Interactive comment on “Integration of remote sensing, RUSLE and GIS to model potential soil loss and sediment yield (SY)” by H. Kamaludin et al.

Received and published: 3 July 2013

Fig. 2. R factor map produced using Morgan (1975)

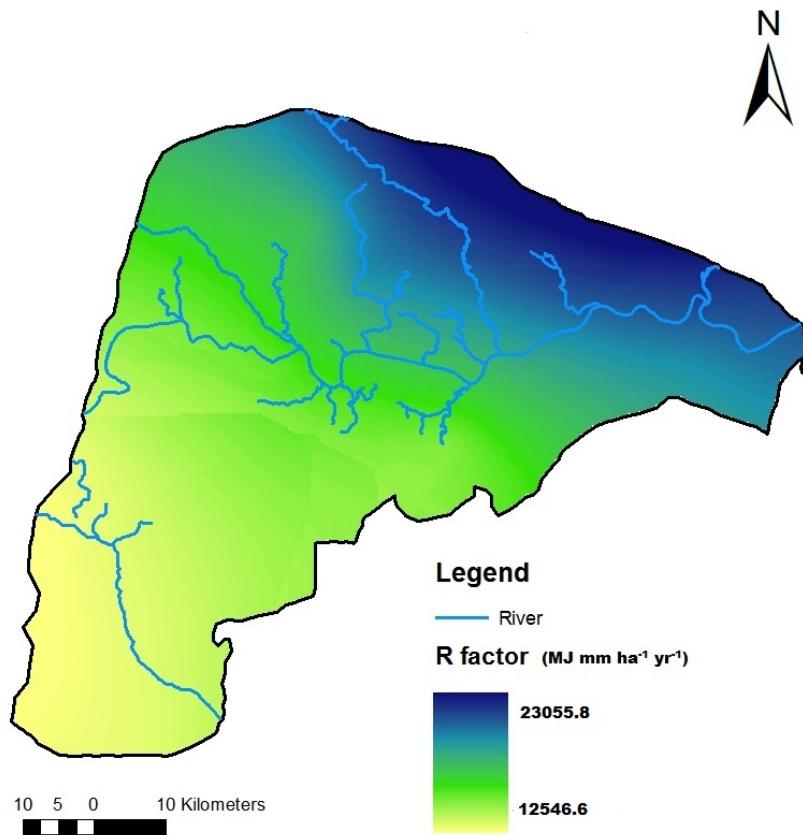
1)R-factor (rainfall erosivity) Two equations Morgan (1975) and Roose (1975) are mentioned and used. Luckily, Morgan's equation was derived from the data of the Malaysian region, but Roose derived his equation from Western African rainfall data and conditions. We know that annual rainfall alone is a very poor predictor of erosivity. E.g. in the northern UK, we may have 2000 mm of annual P, but a rather low annual erosivity (long lasting low intensity rains), where in drier countries with 500 to 750 mm of annual

rainfall may yield a much higher R (e.g. due to high intensity storms). In principle, and at least, the authors should show they validated the R-estimator for their region.

Answer: For the R factor, we have to make some adjustments and only use the Morgan (1975) formula because it was already evaluated for Malaysia case study. Validation for R factor was done by comparison of the analytical results (predicted) using GIS with the R factor from the Department of Irrigation and Drainage Malaysia (DID). The map showed similar pattern of rainfall distribution and the R factor value.

Fig. 3. The flow methodology to produced the LS factor map from DEM

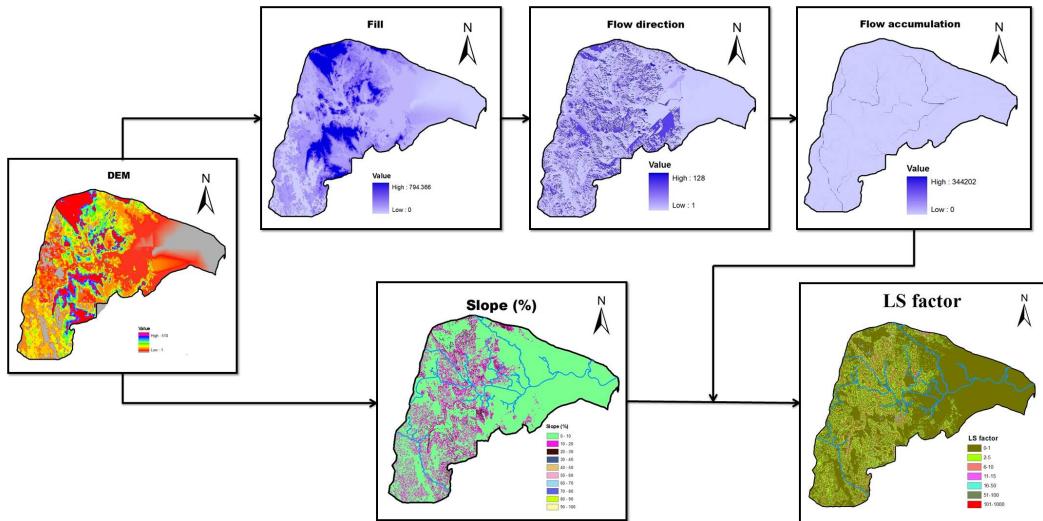
LS factor (topographic) the used a grey literature reference for this factor (Bizuwerk et al, 2008). The equation here is from the old (outdated) USLE (1978). This equation has been evaluated (see Renard, 1993) as outdated, and was replaced by a multiple set of newer LS-functions in RUSLE. The authors should adapt this.

Answer: For the LS factor, there were a few of the correction from the literature reference. The LS factor in the formula by Wischmeir and Smith (1978) were used in both GIS (predicted) and field measurement calculation. In this study, the Bazuwerk et al., 2008) method was used only for calculation slope length and slope gradient in GIS environment. In the GIS environment, the slope length and slope steepness can be used in the single index. A few steps proposed by Bazuwerk (2008) can be used to evaluate the DEM image and convert to LS factor. Besides, the results obtained in GIS can be accepted by results obtained in the field measurement calculation. A table for the verification of these results was added in the manuscript.
